SUBJECT: SURRY POWER STATION, UNIT NOS. 1 AND 2 - ISSUANCE OF
AMENDMENTS REGARDING IMPLEMENTATION OF GENERIC SAFETY
ISSUE 191 (TAC NOS. MC9724 AND MC9725)

AMENDMENT TO RENEWED FACILITY OPERATING LICENSE

SAFETY EVALUATION BY THE OFFICE OF NUCLEAR REACTOR REGULATION

SURRY POWER STATION, UNIT NOS. 1 AND 2

Figure 1. Containment air partial pressure versus service water temperature (proposed TS Figure 3.8-1)

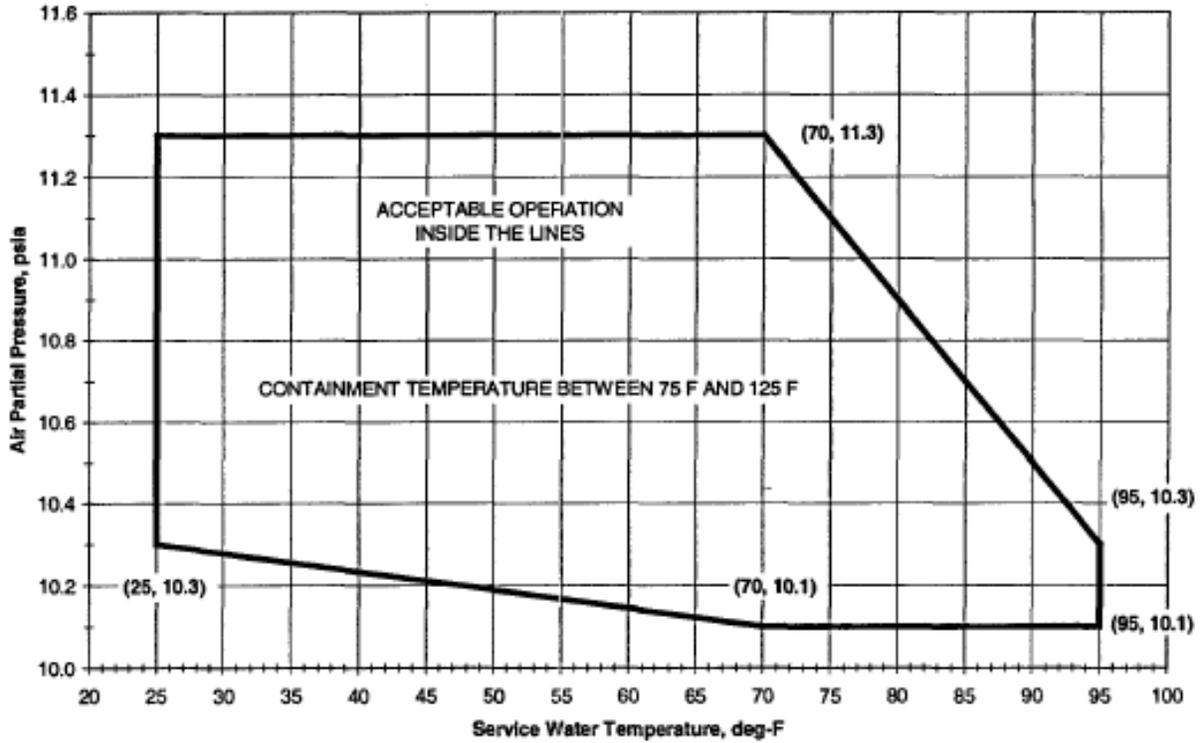
In Section 3.10 of Attachment 1 to its letter, dated January 31, 2006, the licensee describes the proposed TS limits for containment air partial pressure versus SW temperature as given in TS Figure 3.8-1, which is shown in Figure 1.

This operating domain maintains the current limits of 25-95 °F for service water temperature and 75-125 °F for containment temperature, and accounts for 0.25 psi instrument uncertainty

for the containment air partial pressure. The following defined the allowable containment air partial pressure limits as shown on Figure 1:

- The MSLB peak pressure analysis limits the maximum operating air partial pressure to 11.3 psia. The LOCA peak pressure (58.43 psia for the proposed configuration, Section 3.2.3) is less than the MSLB peak pressure (59.48 psia for the proposed configuration, Section 3.2.7). The MSLB analysis sets the TS upper limit between 25 and 70 °F SW temperature.

- The containment depressurization analyses (Section 3.2.4) set the TS upper limit from 11.3 psia at 70 °F service water to 10.3 psia at 95 °F service water. The allowable air pressure decreases with increasing service water temperature because it is more difficult to depressurize the containment at higher service water temperature. To meet subatmospheric requirements, the initial air partial pressure is limited to 10.3 psia at 95 °F SW.

- The LHSI pump NPSH analyses (Section 3.2.5) set the lower limit on air partial pressure (the RS pumps use the same assumptions but have more NPSH margin (Section 3.2.6)). At the same air partial pressure, the NPSH analyses are limiting at 25 °F SW. Therefore, the TS lower limit is sloped below 70 °F to recover LHSI pump NPSH margin. The proposed lower limit in Figure 1 ensures at least 1.6 ft of NPSH margin across the entire SW temperature range.

The NRC staff determined that the licensee's analyses described in Sections 3.2.3 through 3.2.7 of this report provide bases for the proposed changes to TS Figure 3.8-1.
